### ADDENDUM NO. 1

To the Drawings and Project Manual dated 16 June 2017

**TAS/ADA FIRE MARSHAL  
DEFERRED MAINTENANCE PROJECTS  
MIDWESTERN STATE  
UNIVERSITY**

Addendum Date: 2 August 2017

BOLIN SCIENCE HALL - FIRST FLOOR - AREA 1C  
FIRE PROTECTION PLAN

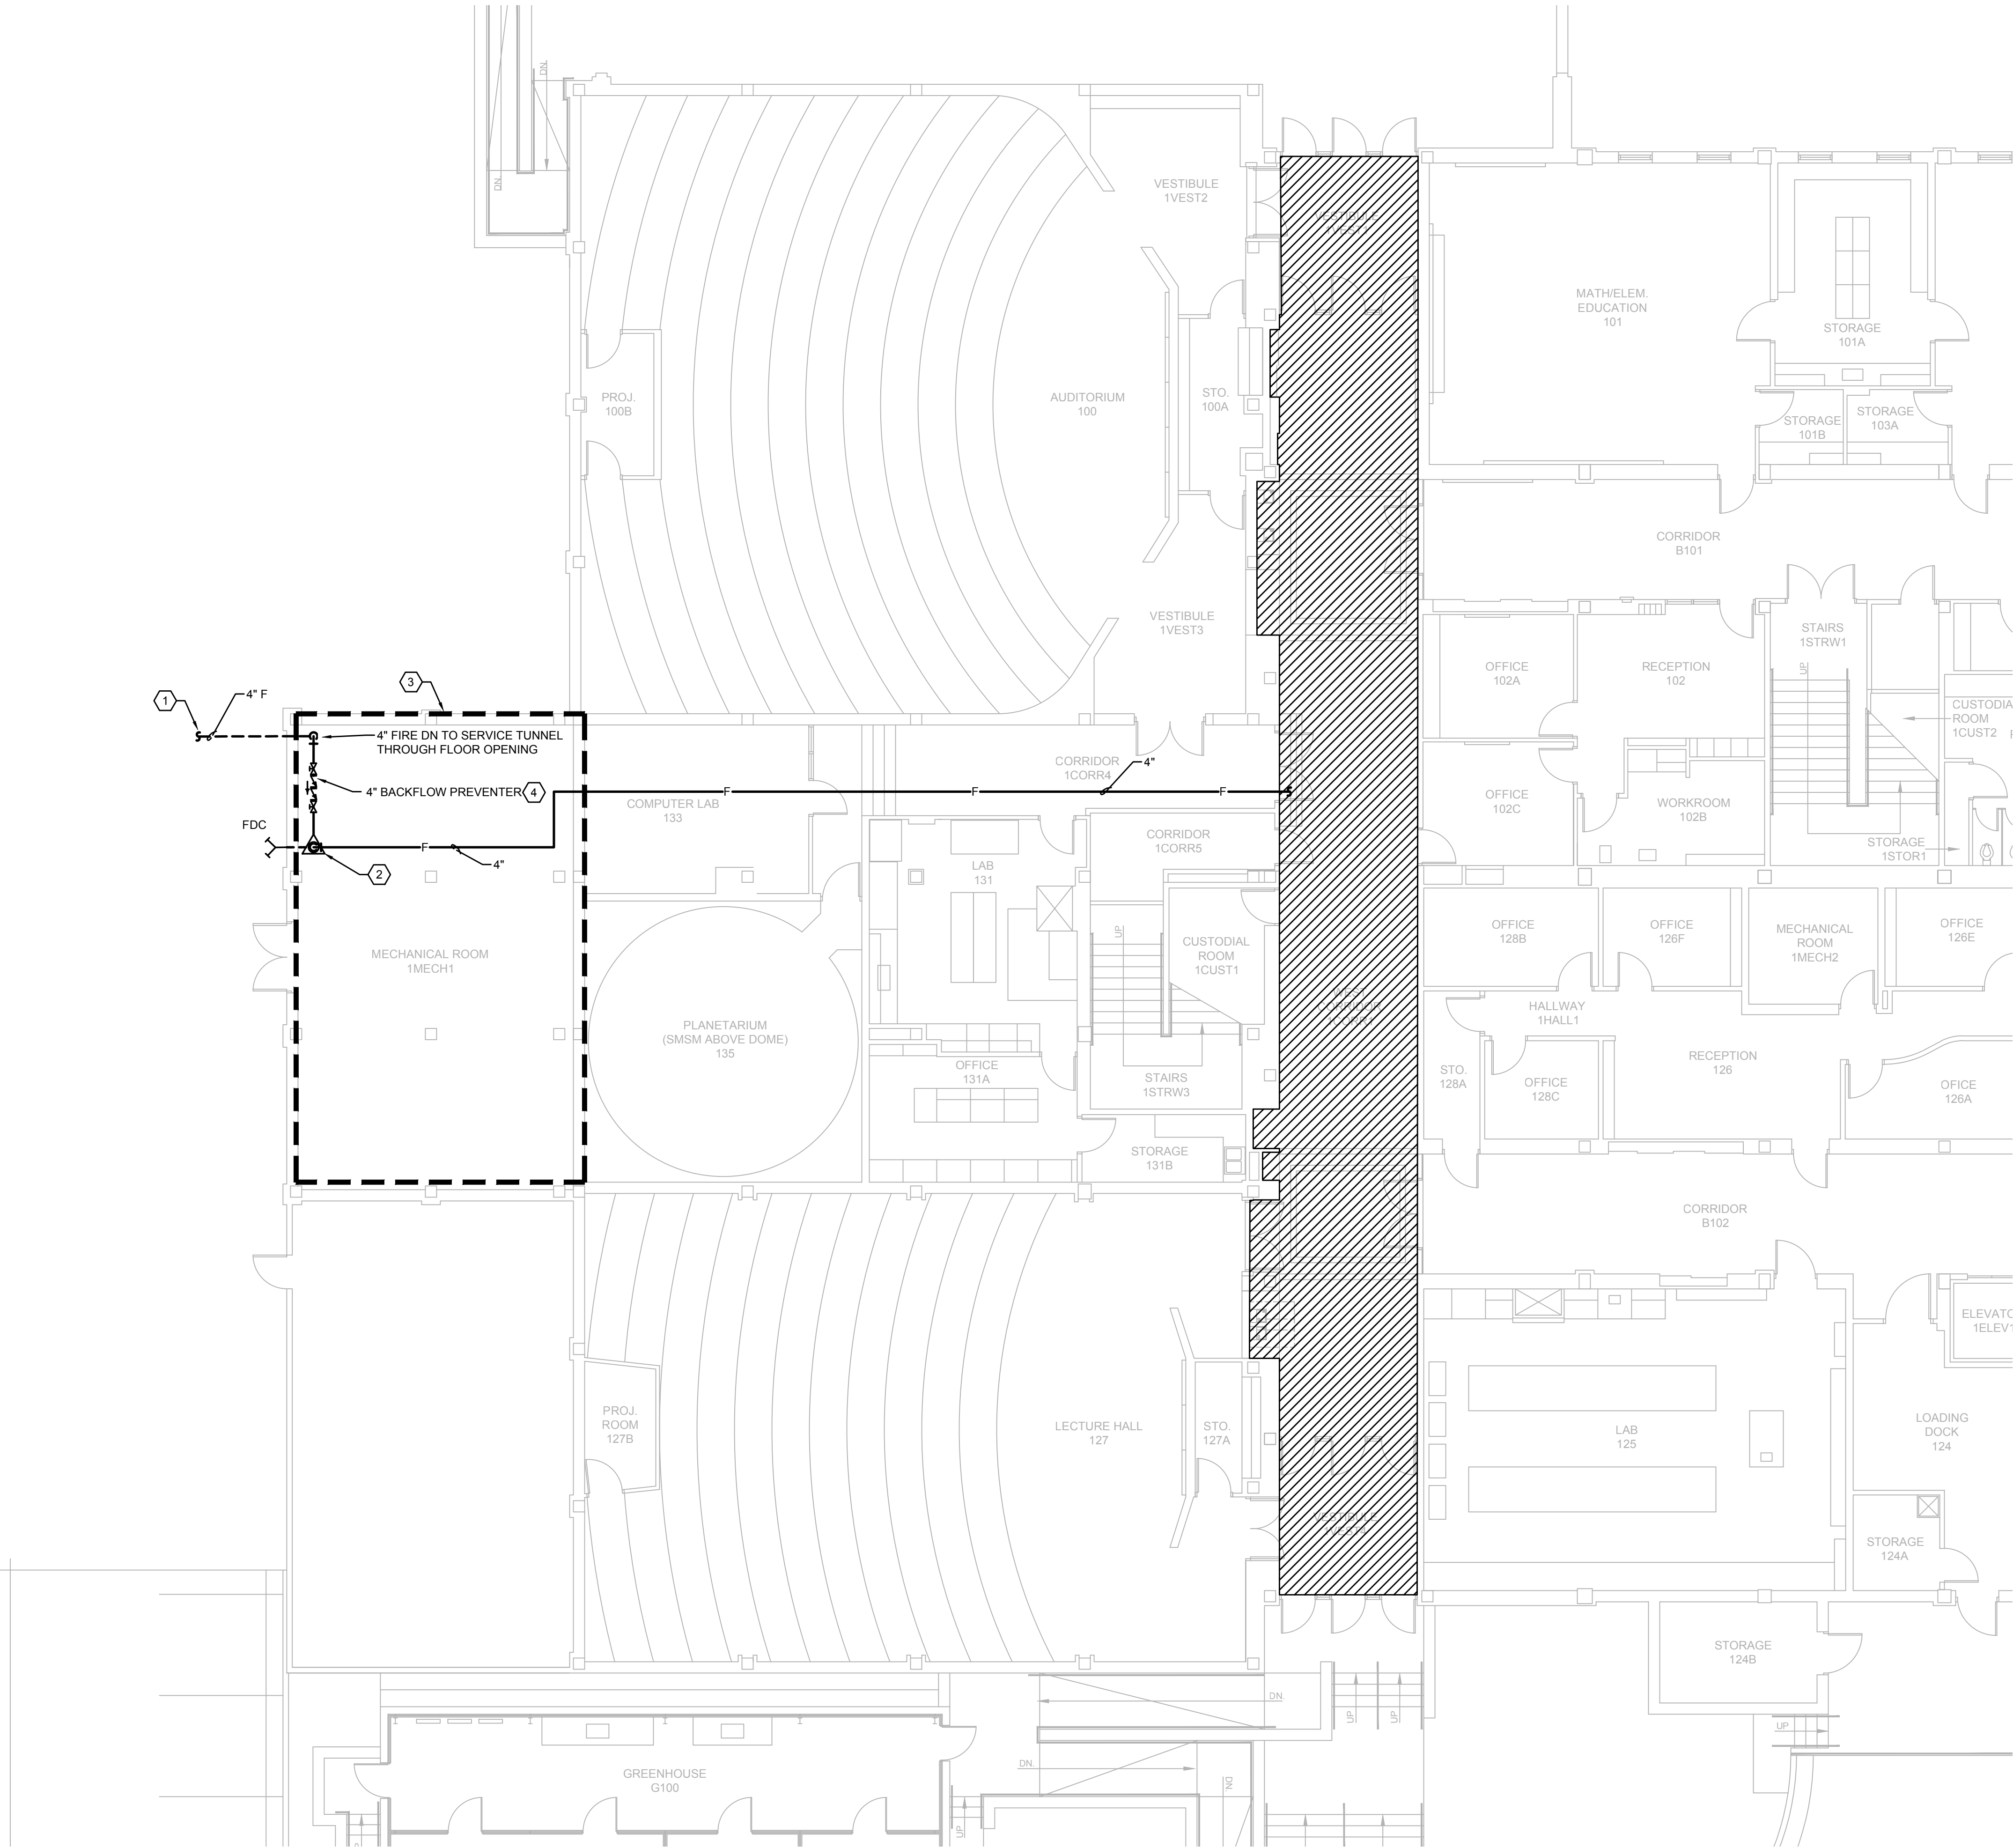
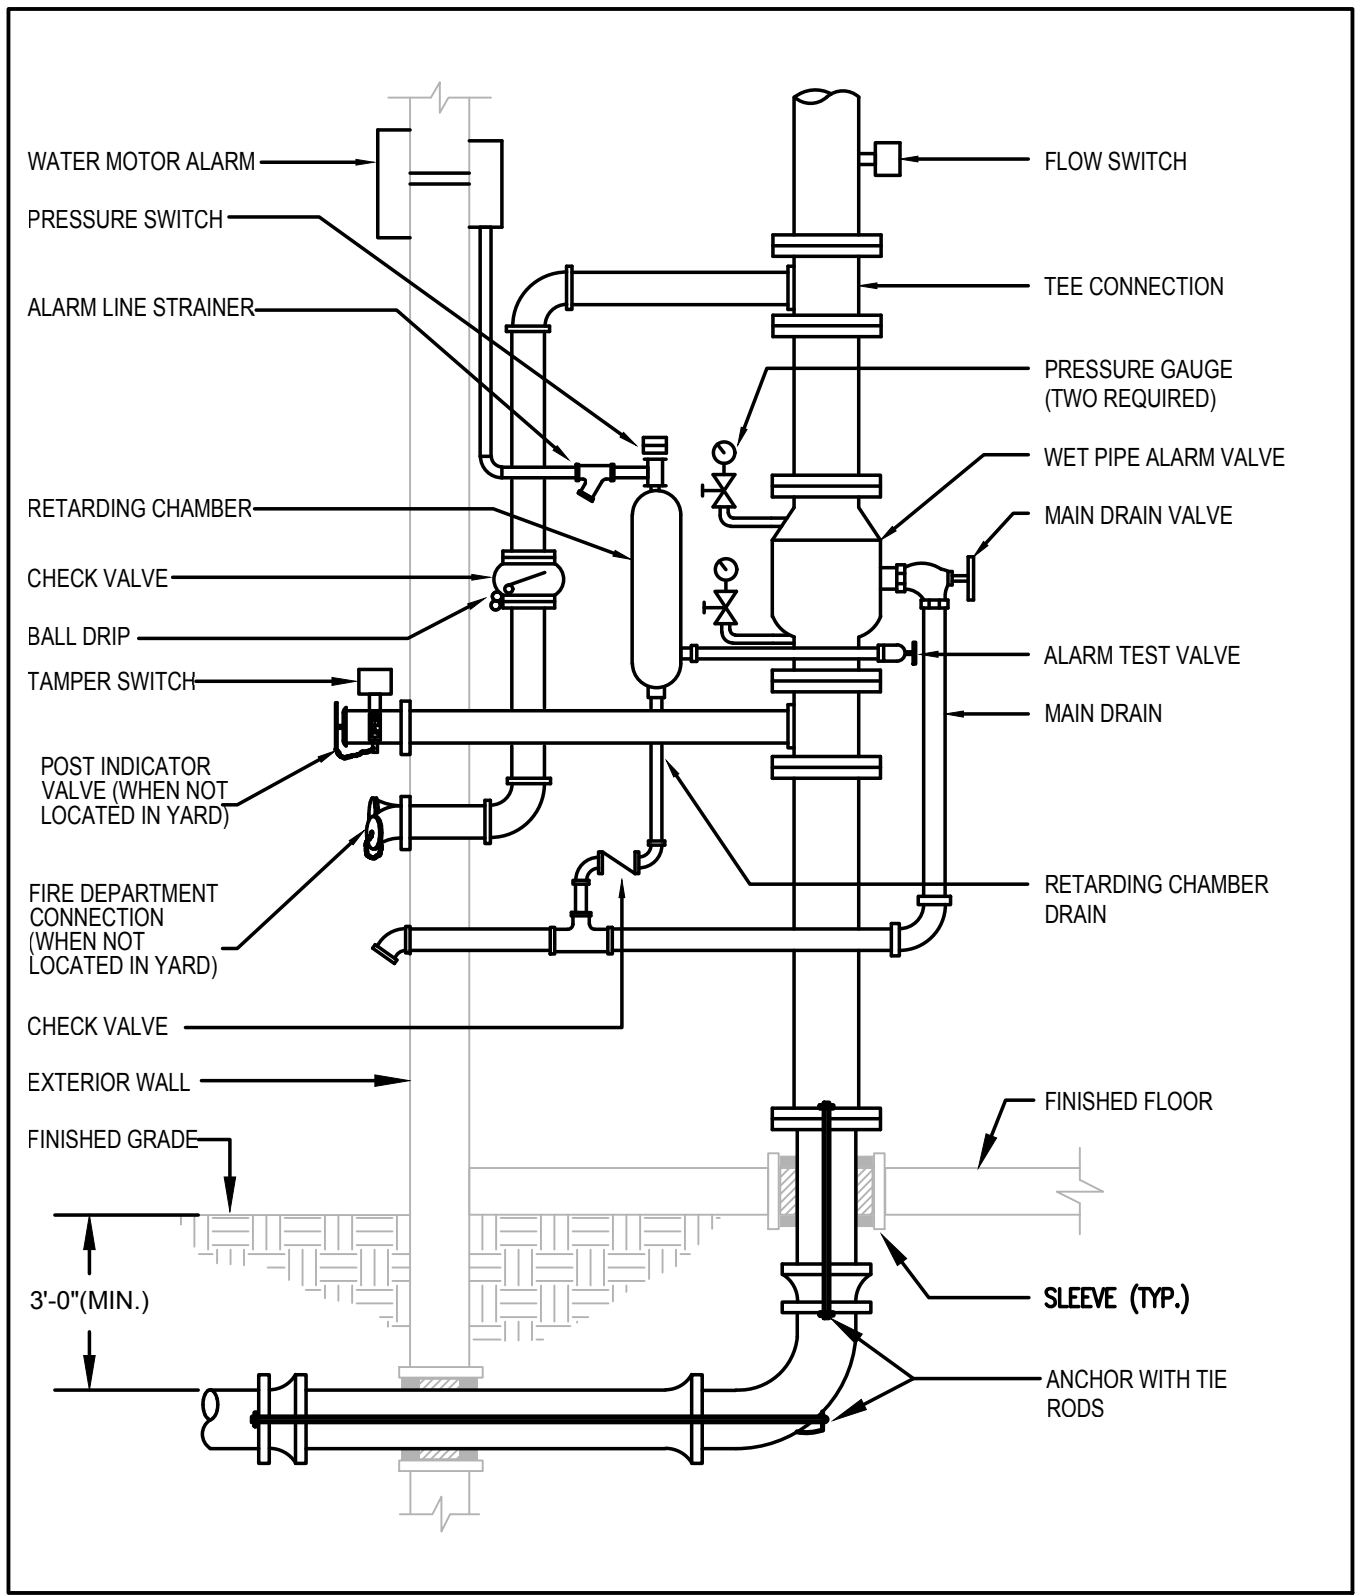
1. Sheet B-FP101 – Revised Drawing as follows:
  - a. Modified Key notes #1, to direct the contractor to the electrical sheet B-E101 for electrical information about the heat trace.
2. Specification Section 210010 General Requirements for Fire Suppression Systems:
  - a. Modified said specification section to remove the use of CPVC piping and the mention of housing facilities.

### FAIN FINE ARTS - FIRST FLOOR - AREA 1A PLUMBING PLAN

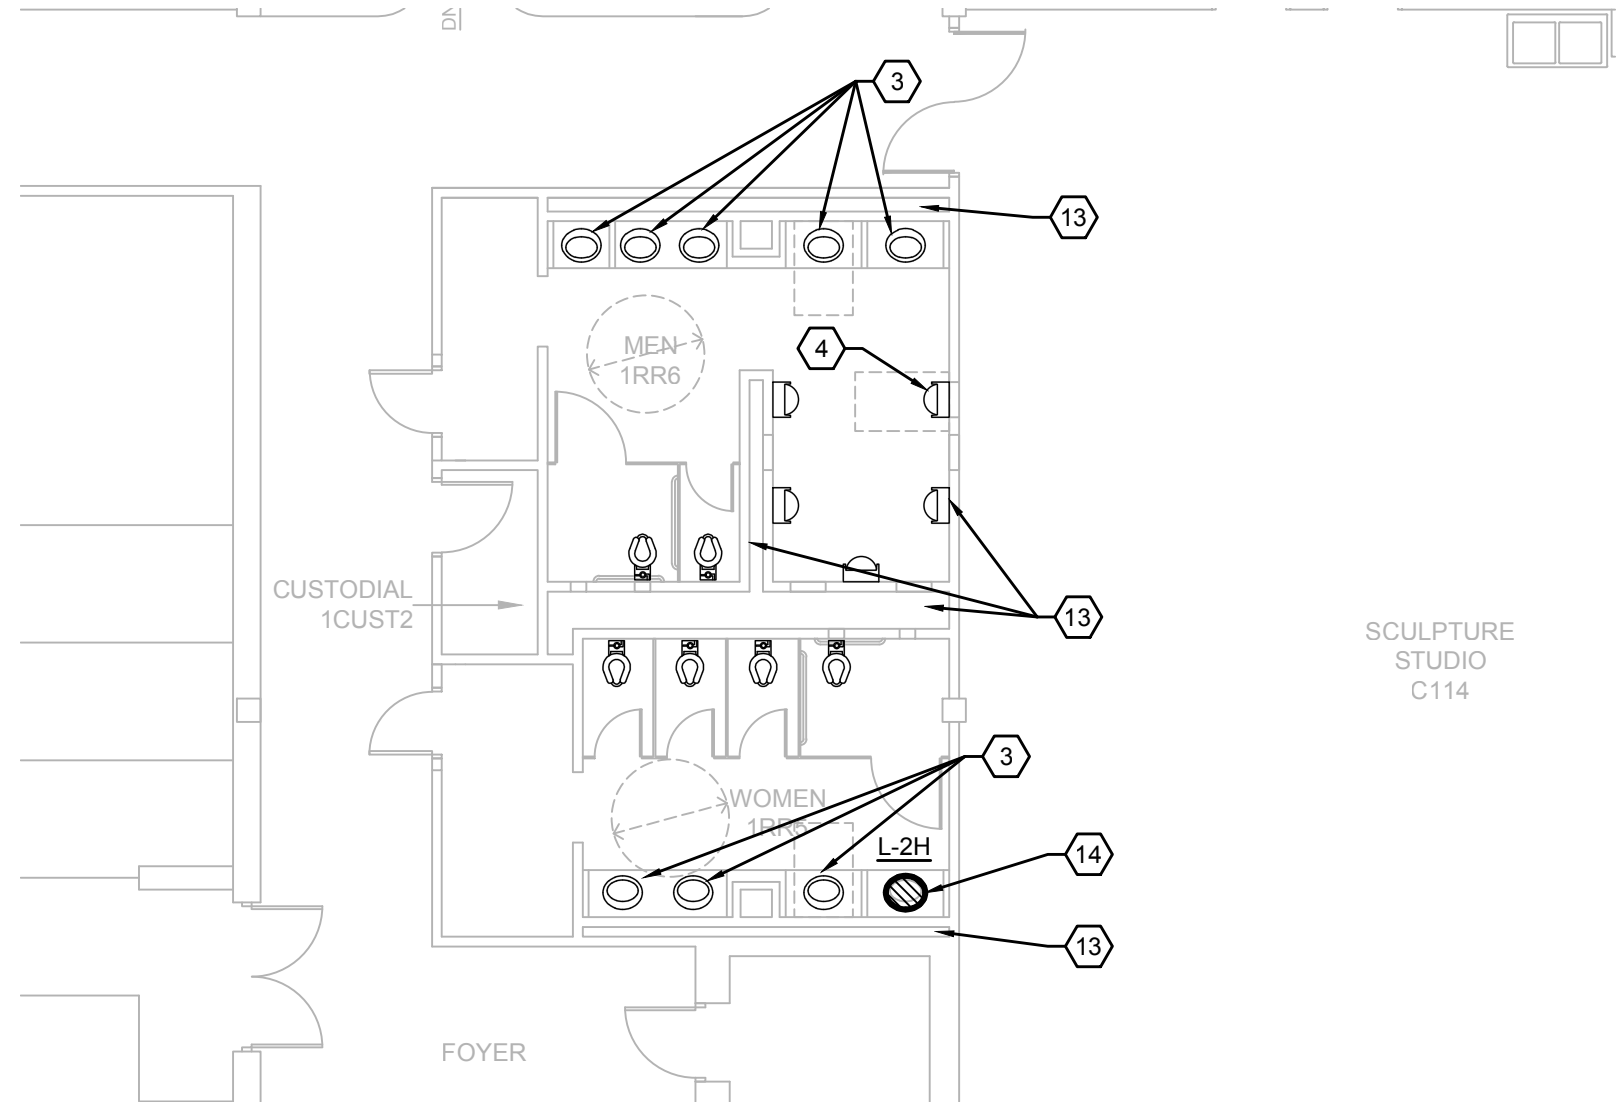
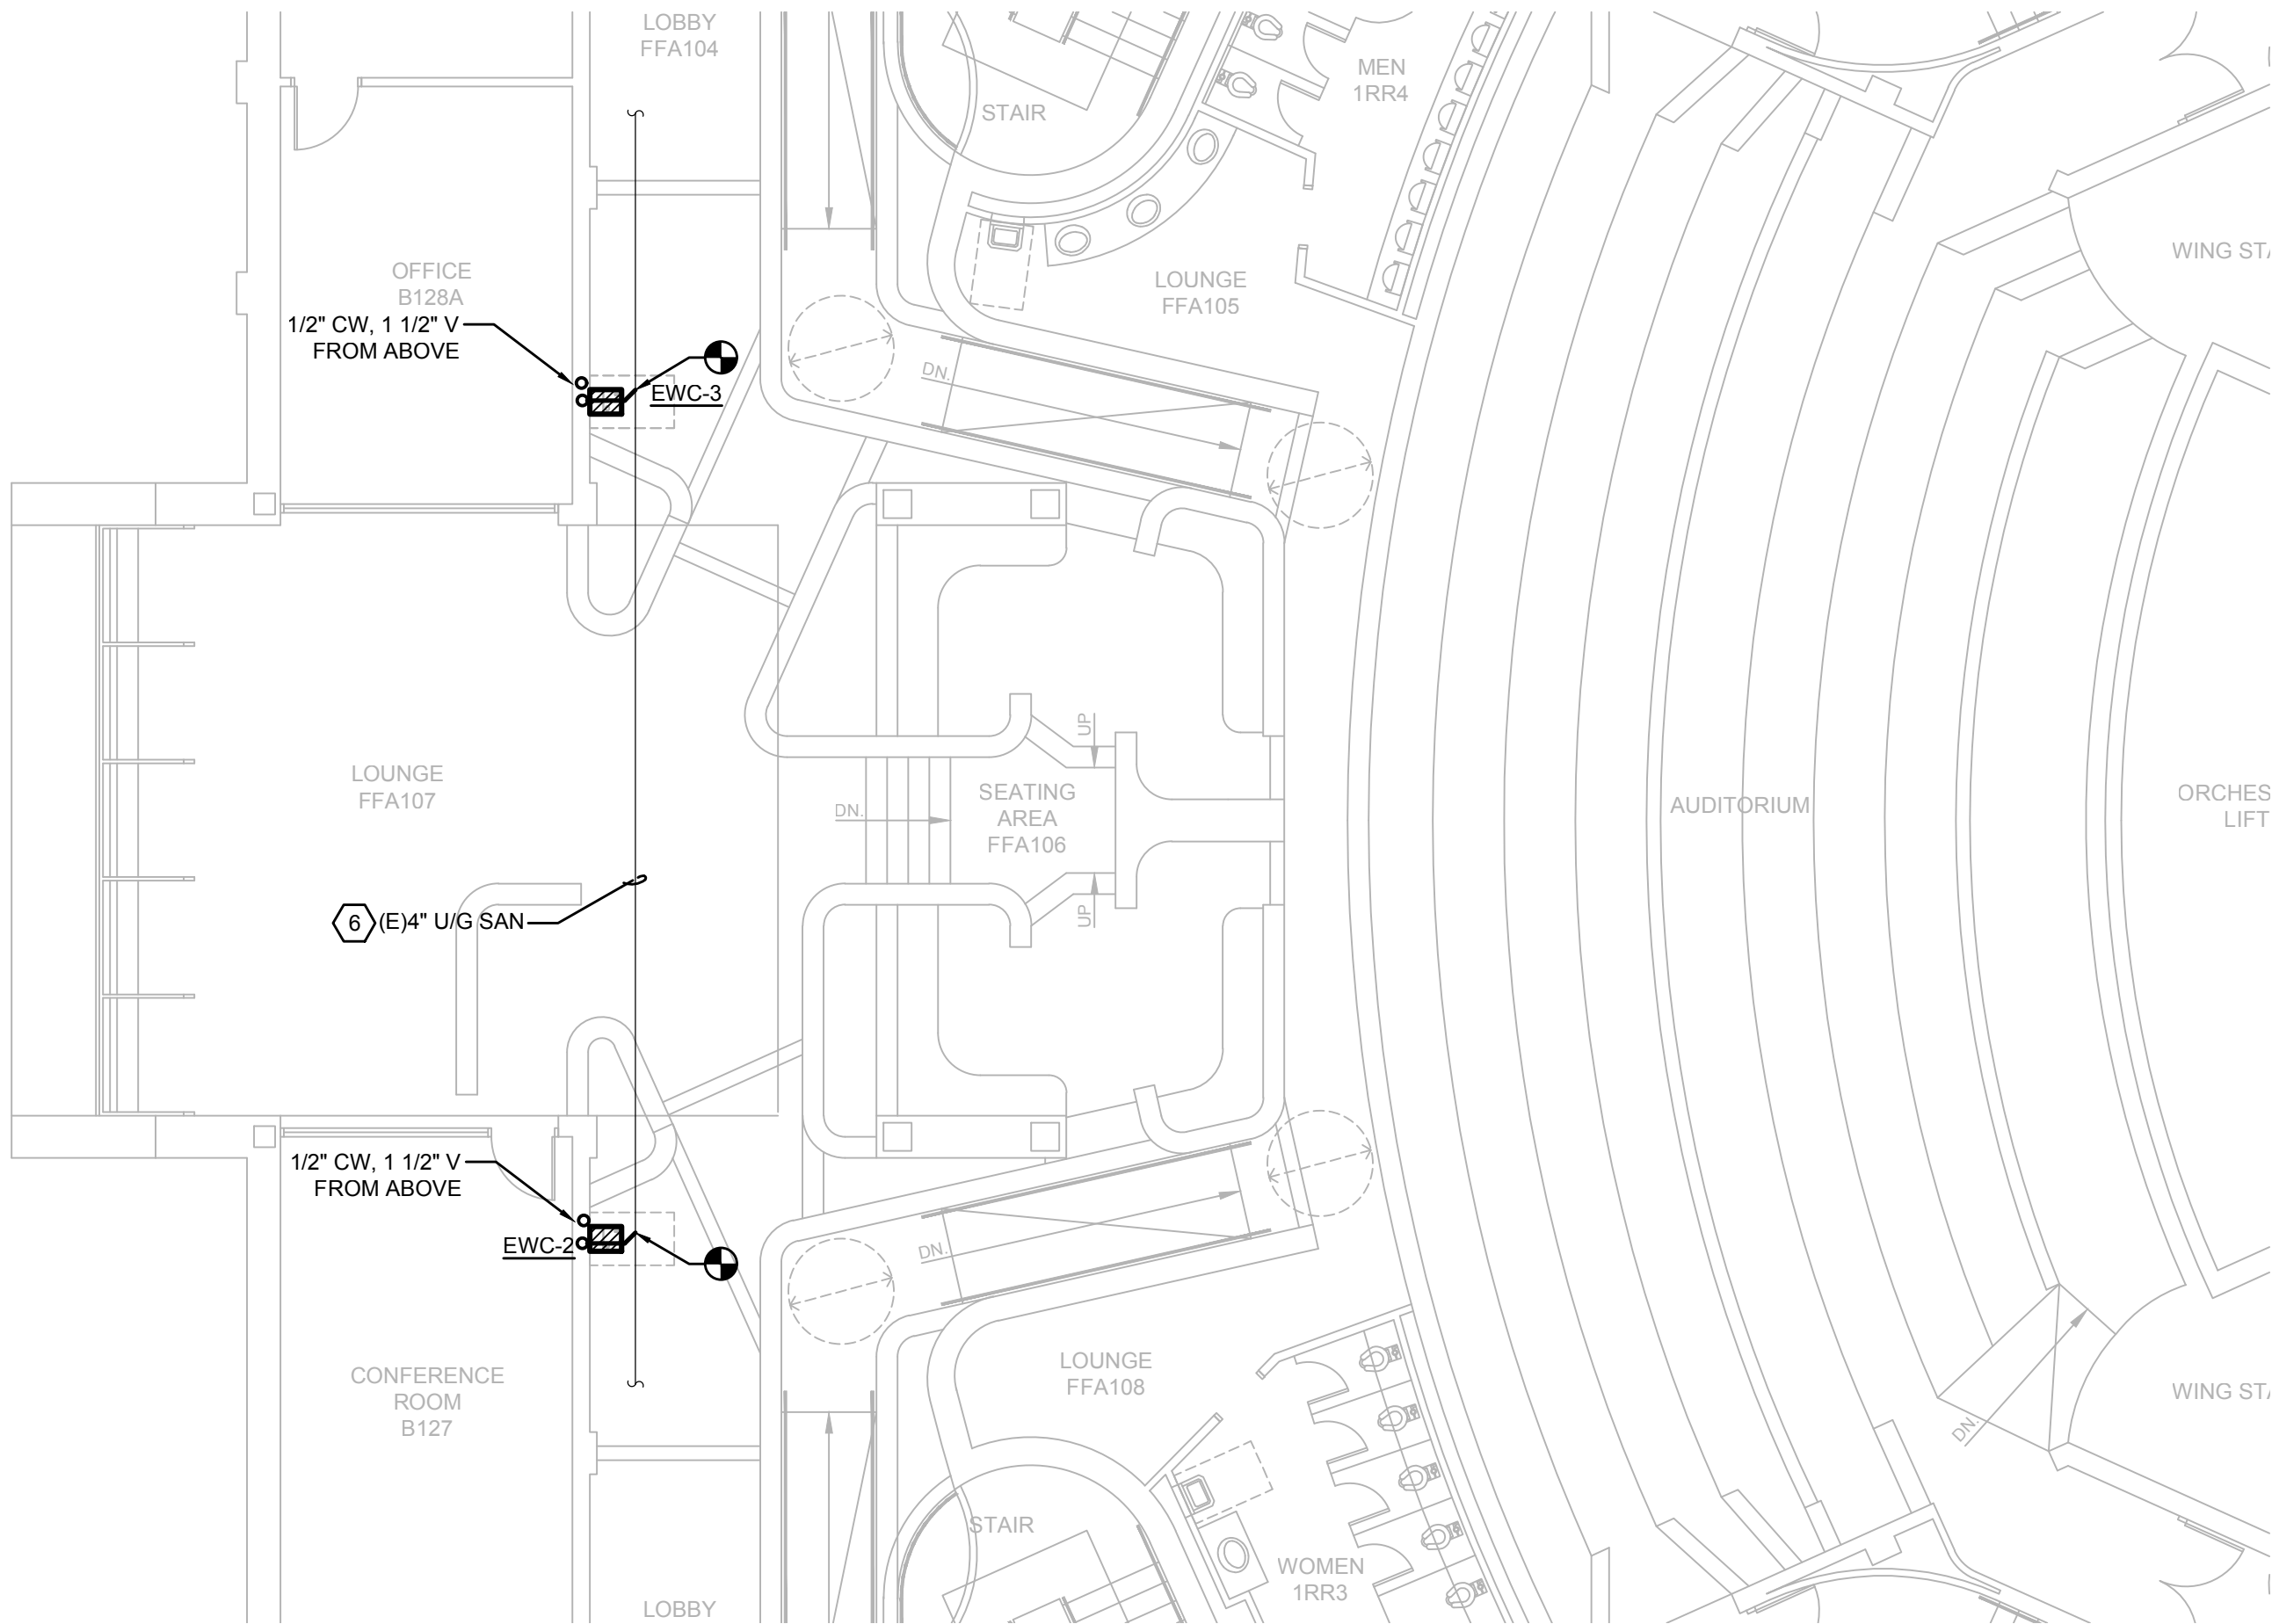
1. Sheet FF-P101 – Revised Drawing as follows:
  - a. Modified Key notes #1, #2 and #3 to clarify the need to provide new plumbing appurtenances to the reinstalled plumbing fixtures.
2. Sheet FF-P102 – Revised Drawing as follows:
  - a. Modified Key notes #1, #2 and #3 to clarify the need to provide new plumbing appurtenances to the reinstalled plumbing fixtures.
